INSTRUCTIONS FOR INSTALLING THE 199779 MODIFICATION
KIT TO SECURE FINAL ADJUSTMENT OF THE CODE READING
CONTACTS ON CX1

FIGURE 1

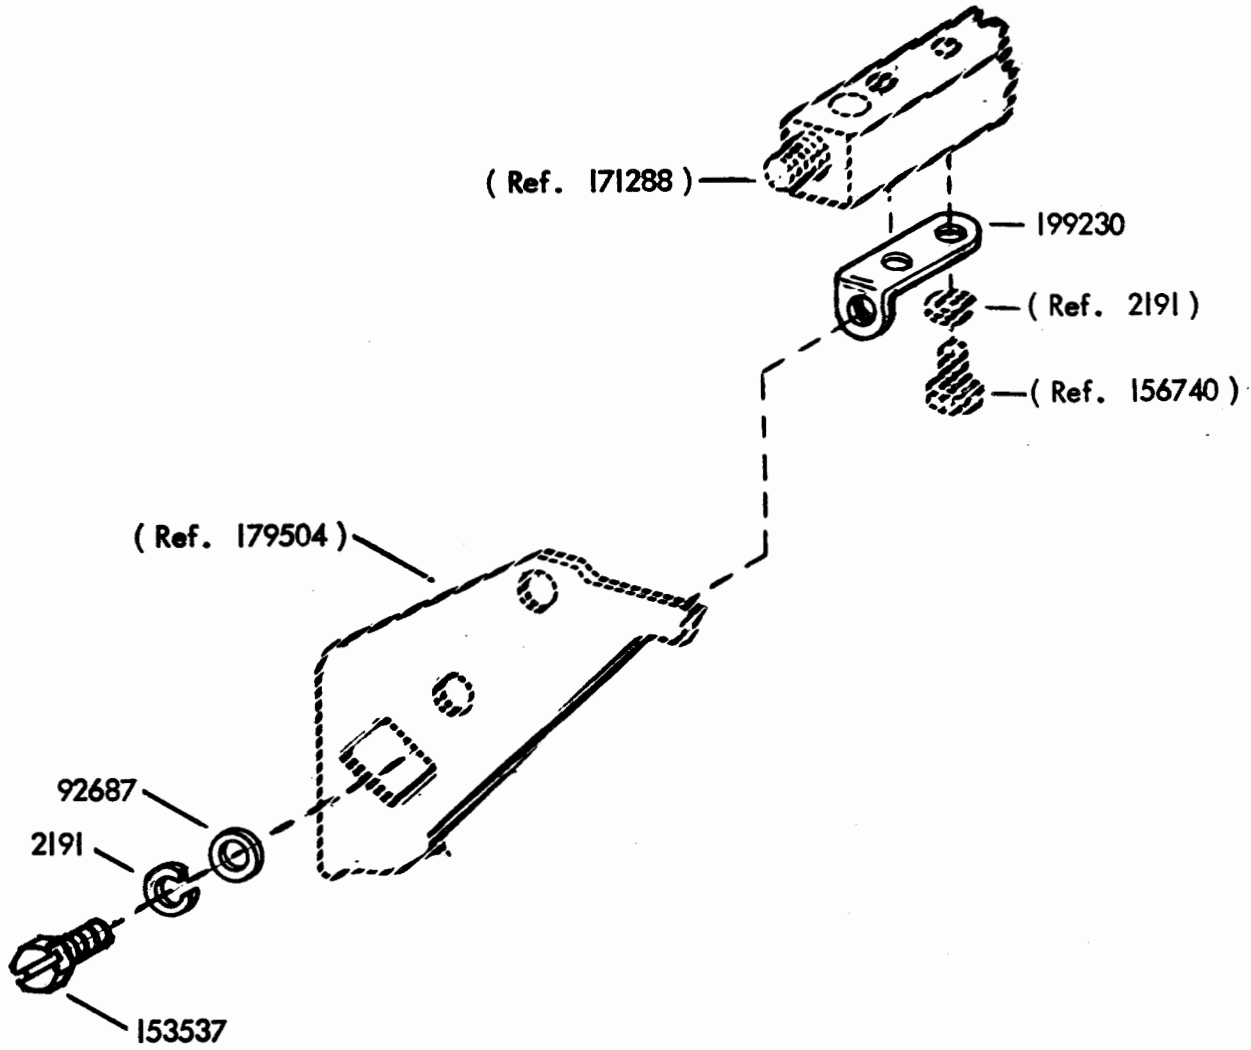
a. Remove and retain two 156740 Screws and 2191 Lock Washers which hold the 171241 Bracket to the post. Discard the 171241 Bracket. Position new 199230 Bracket at the same location with projection pointing down at the front of the unit and fasten with retained hardware.

b. Fasten 199230 Bracket to 179504 Plate with 153537 Screw, 92687 Flat Washer and 2191 Lock Washer through square opening in plate.

b. When making the Contact Installation Adjustment, as found in Bulletin 267B, the 199230 bracket must be loosened by means of the contact mounting nuts and these nuts tightened after adjustment.
